ADDENDUM NO. 1

Schertz Seguin Local Government Corporation

Contract 3 - 36" Pipeline

October 27, 2020

DESIGNED	JFW
DRAFTED	ARC
CHECKED	JFW
PROJECT NO.	1-03153
DRAWING NO.	C006

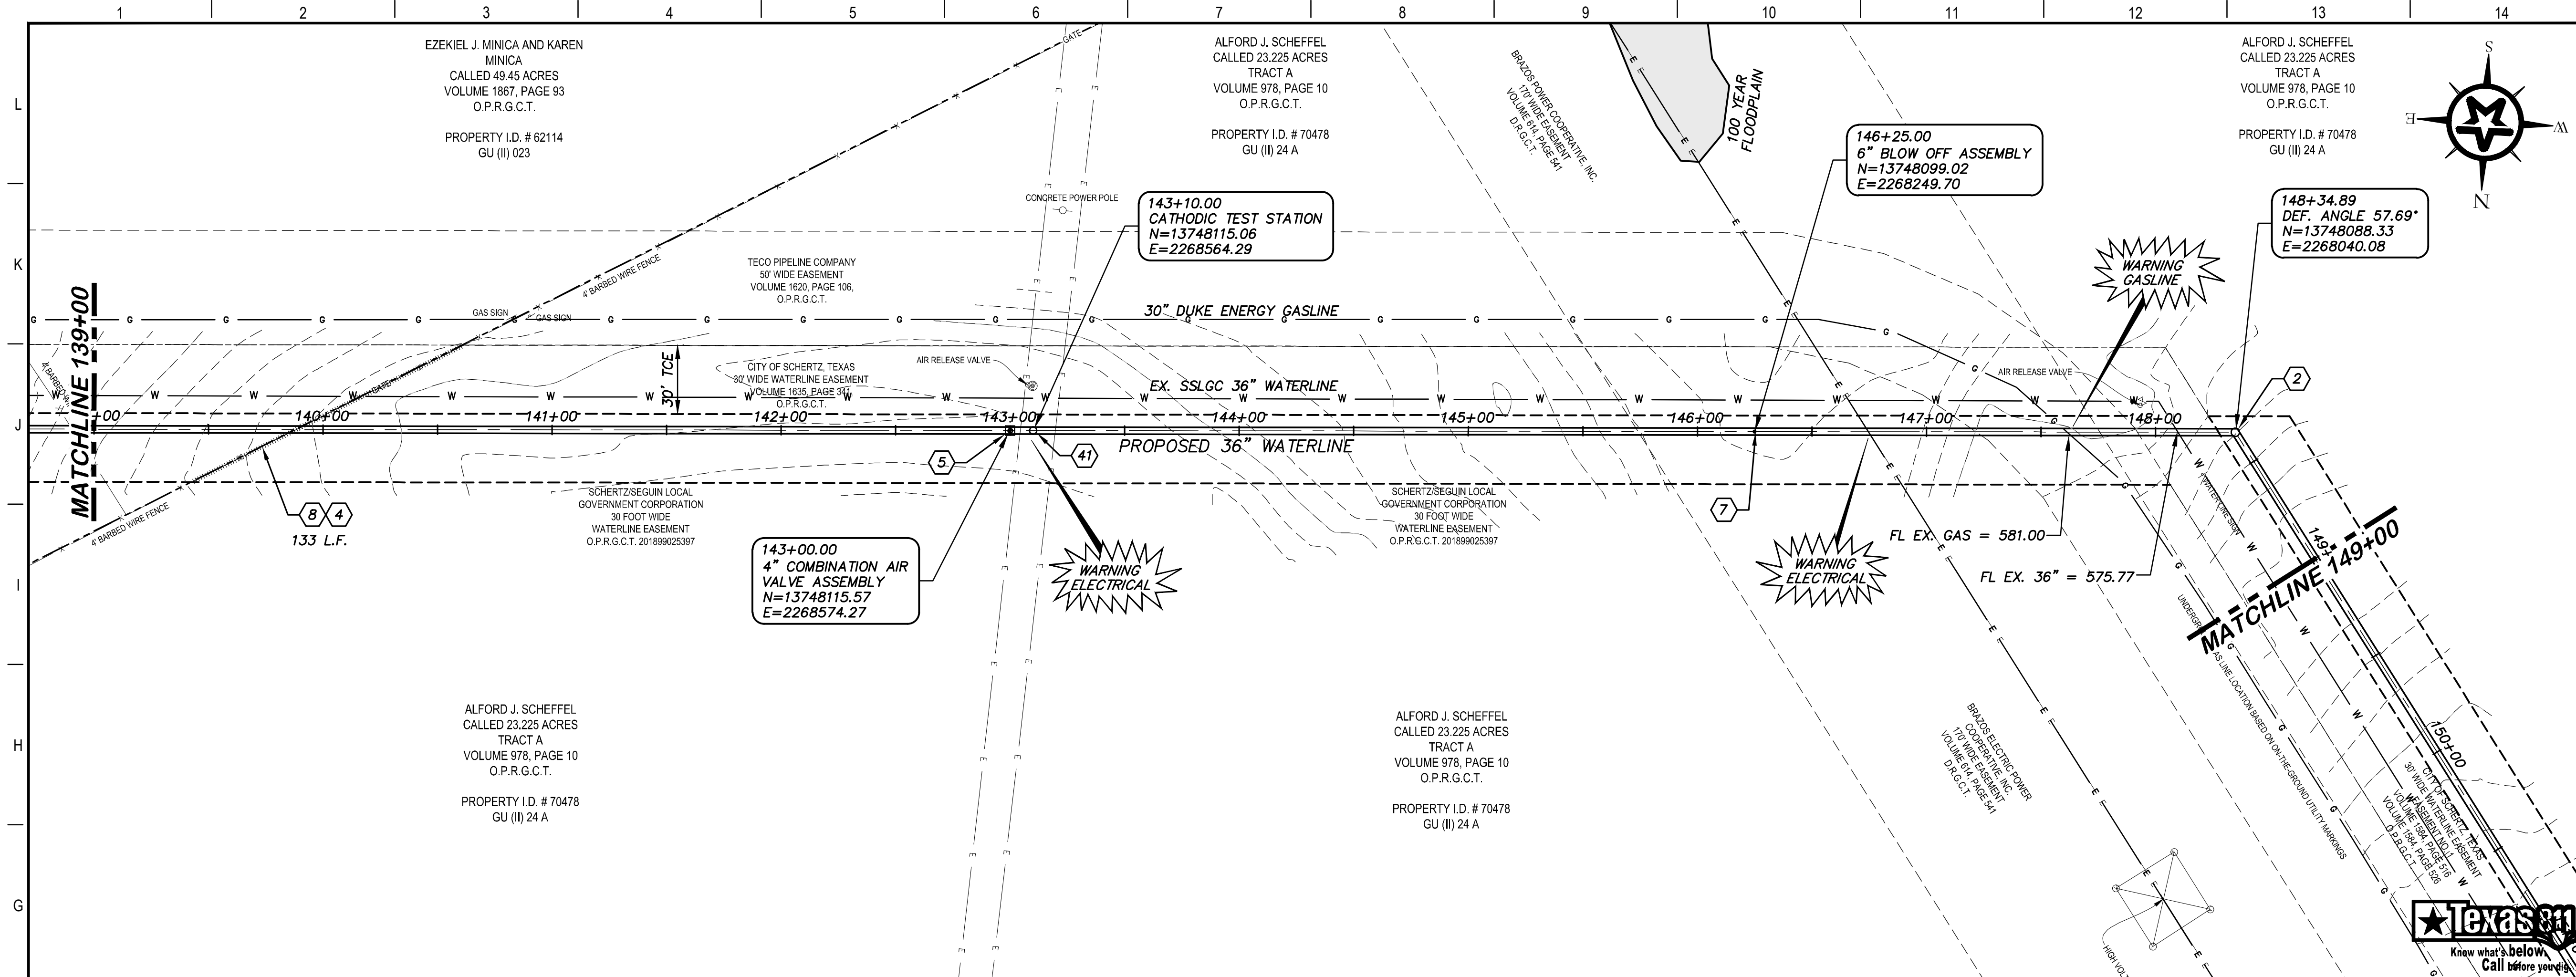
1. Sheet C006. Blow-off valve assembly added to profile.
2. Sheet C114. Profile of pipeline is amended to accommodate the Air Valve Assembly. Use the attached sheet for this Project.

DESIGNED	JFW
DRAFTED	JFW
CHECKED	ARC
PROJECT NO.	1-03153
DRAWING NO.	C114

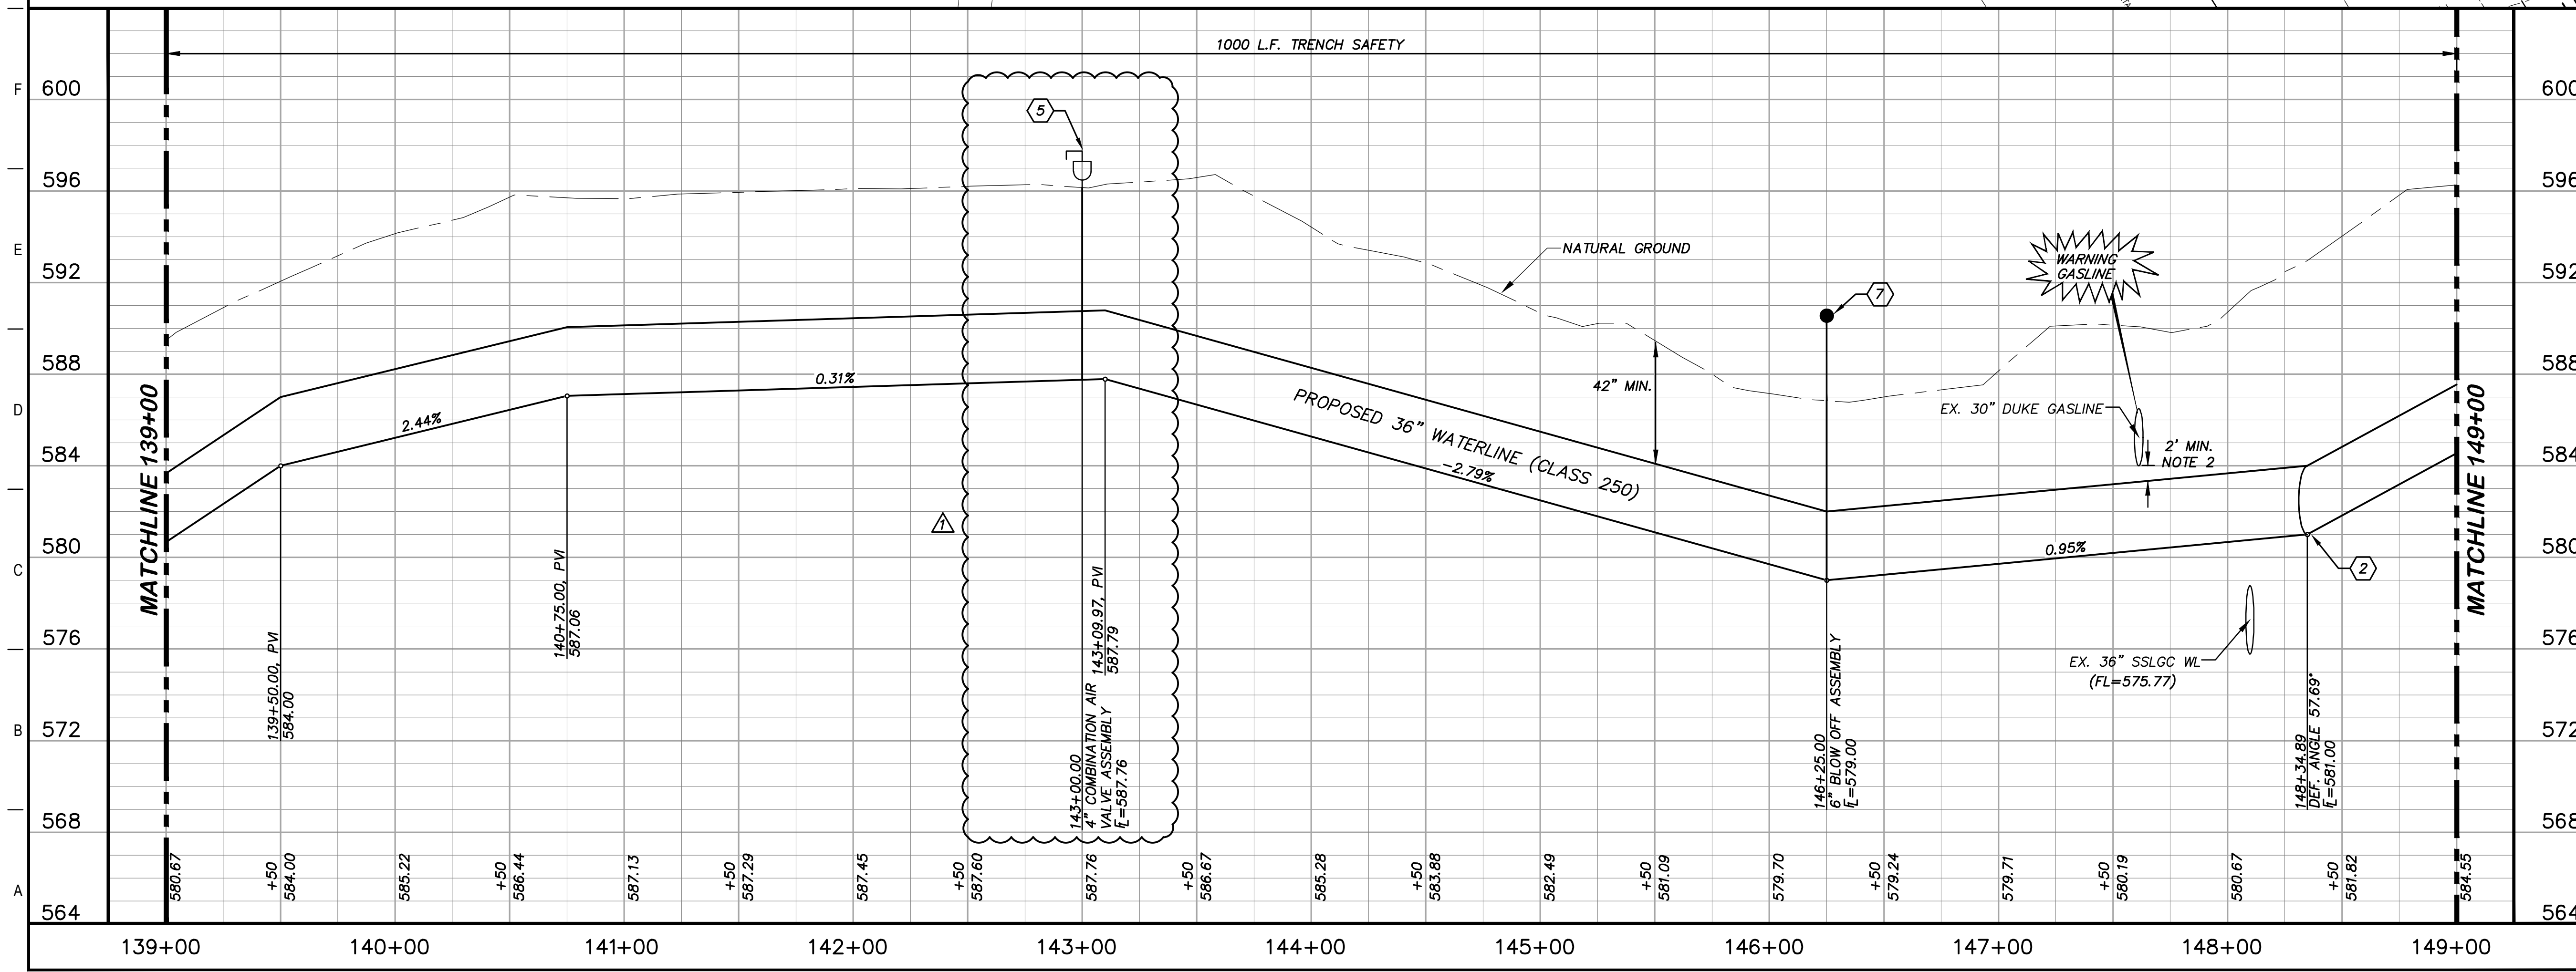
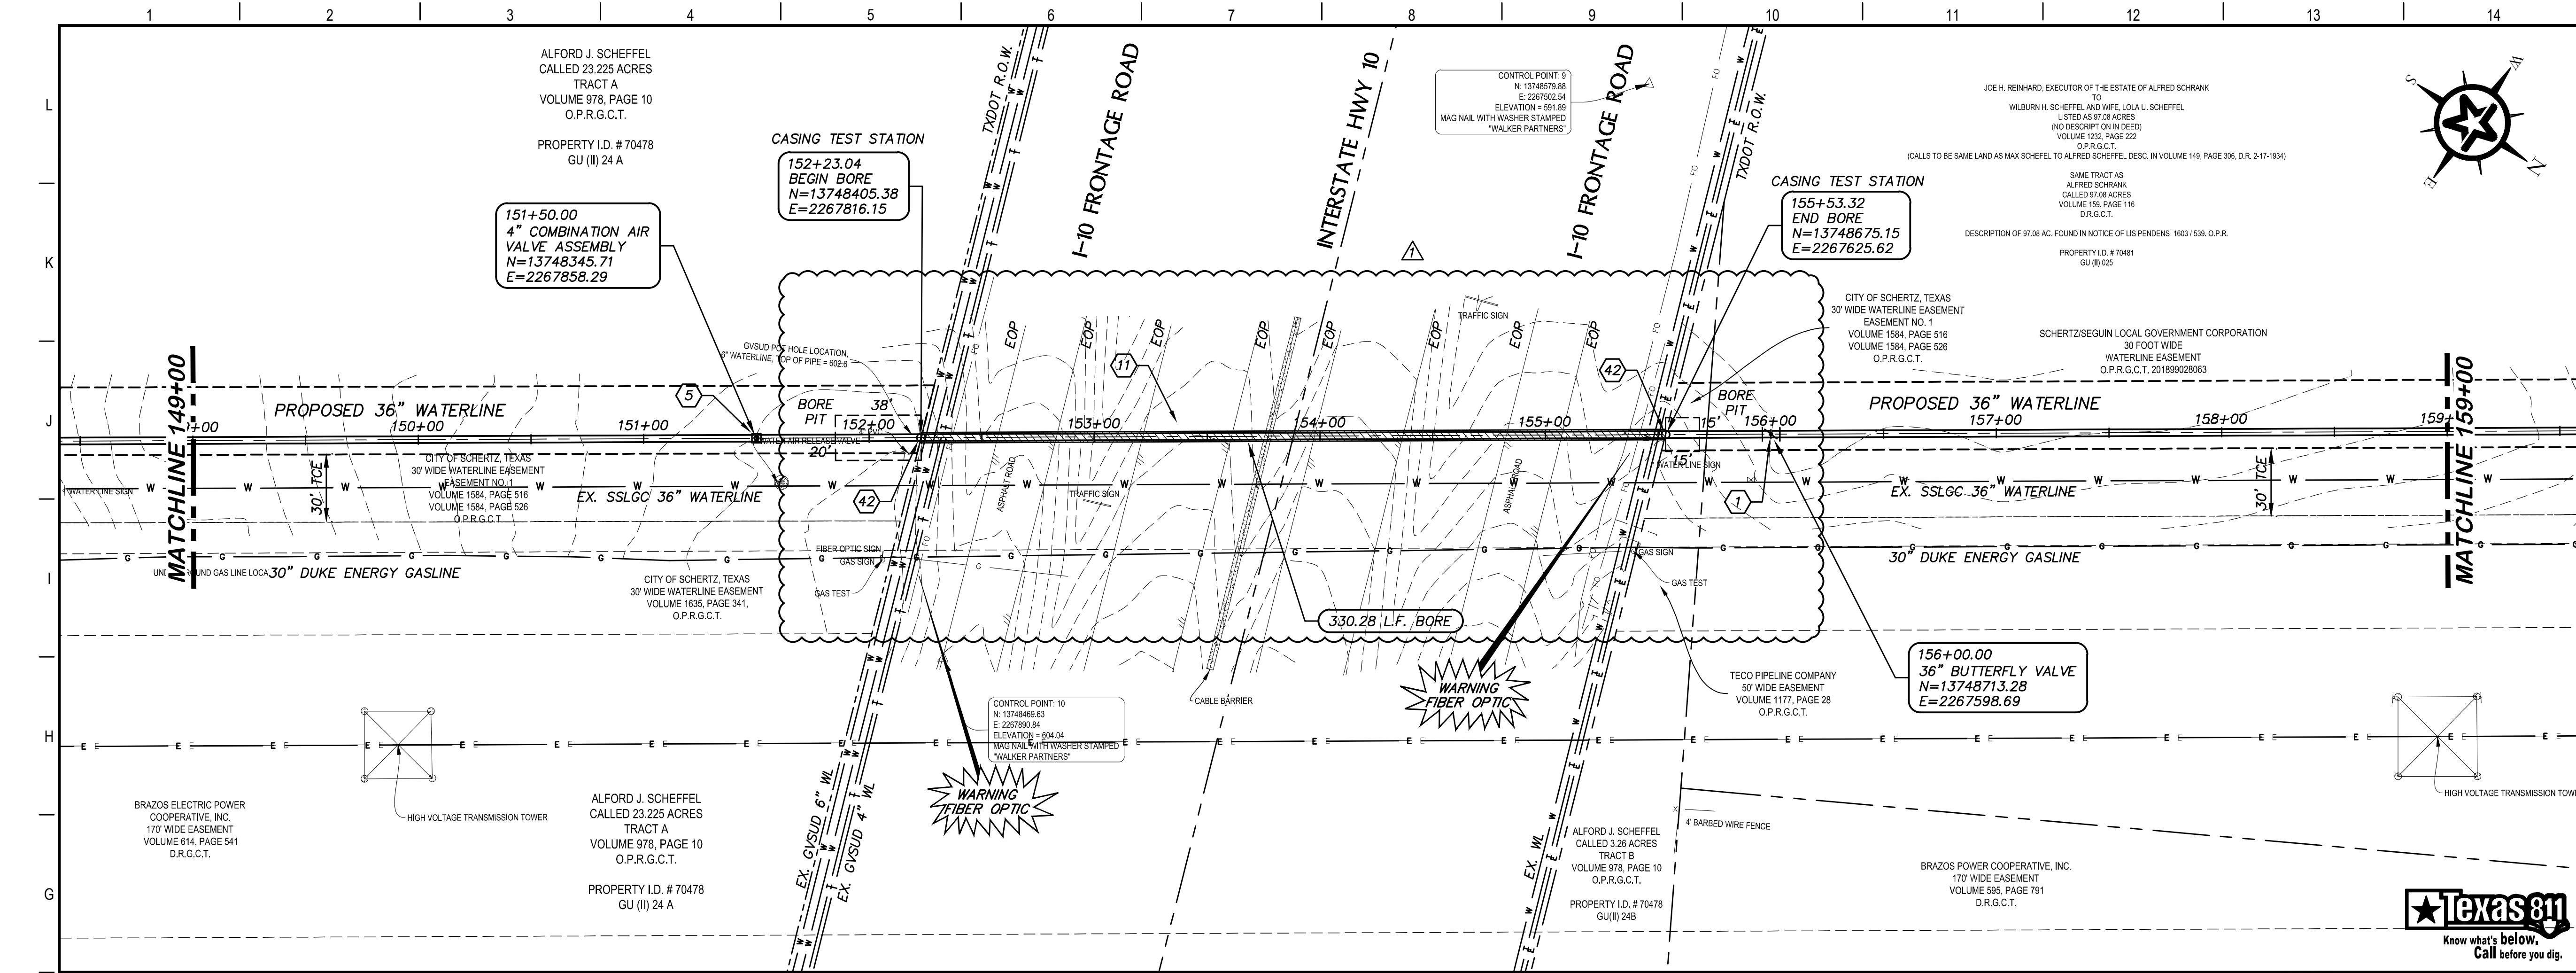
5. Sheet C114. Profile of pipeline is amended to accommodate the Air Valve Assembly. Use the attached sheet for this Project.
6. Sheet C145. Flowable Fill above casing deleted.
